# ProtoDUNE cryostat penetrations update

# Cryostat changes

## CHANGE OF THE HEIGHT

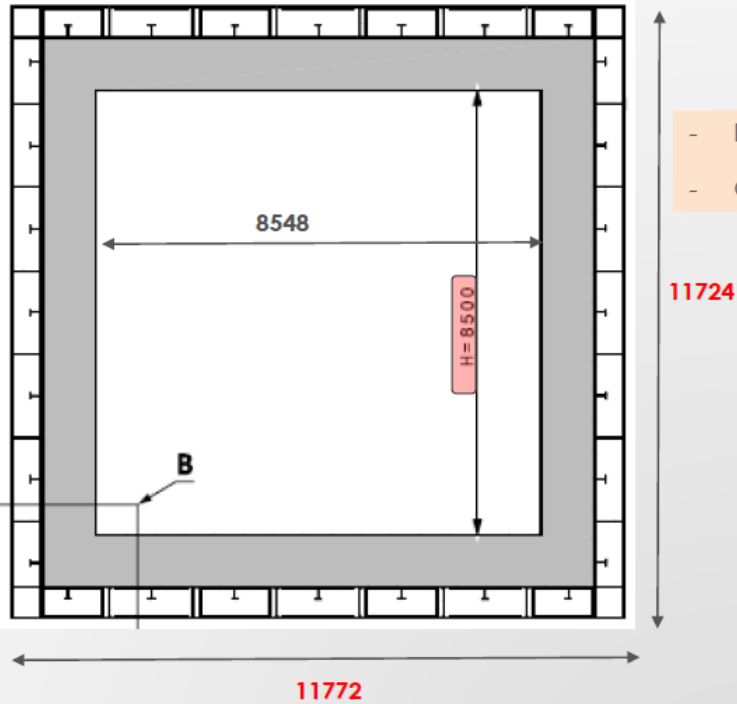
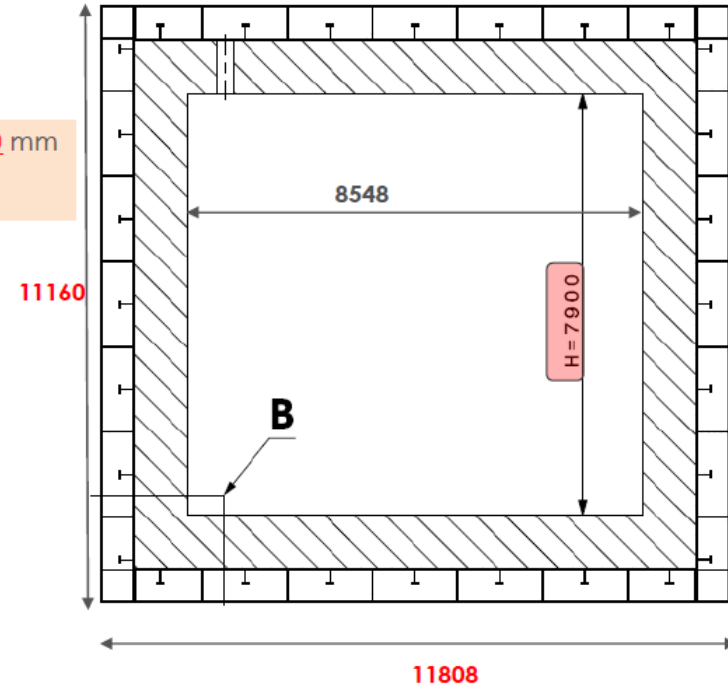
- Inner Height : Reduced by 600 mm
- Change of IPE profiles

Length [mm]	Width [mm]	Height [mm]
Membrane Flat Internal dimensions	8548	8548	8500
SS Plate Internal Dimensions	10552	10552	10504
External Dimensions of the Structure	11772	11772	11724

Length [mm]	Width [mm]	Height [mm]
Membrane Flat Internal dimensions	8548	8548	7900
SS Plate Internal Dimensions	10552	10552	9904
External Dimensions of the Structure	11808	11808	11160

## PROTODUNE - TCO

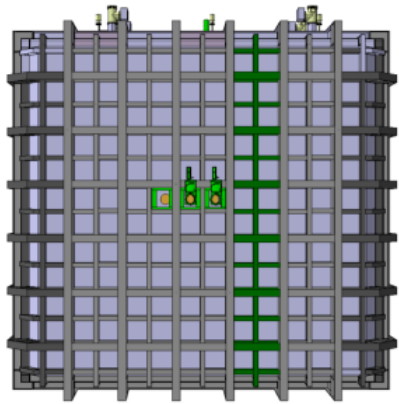
# TCO for installation moved to side with beam window

TCO Stainless Steel  
Plate – Side View

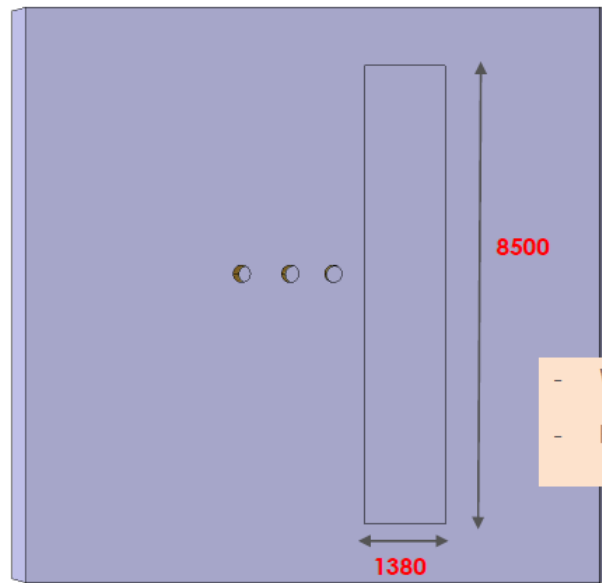
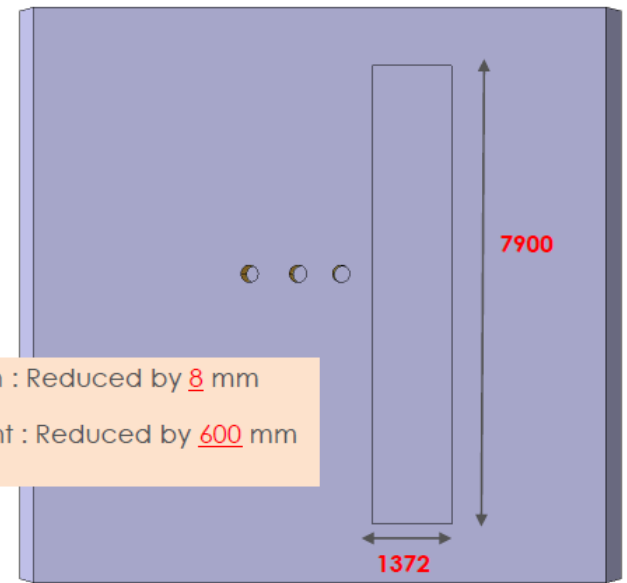
- Width : Reduced by 8 mm
- Height : Reduced by 600 mm
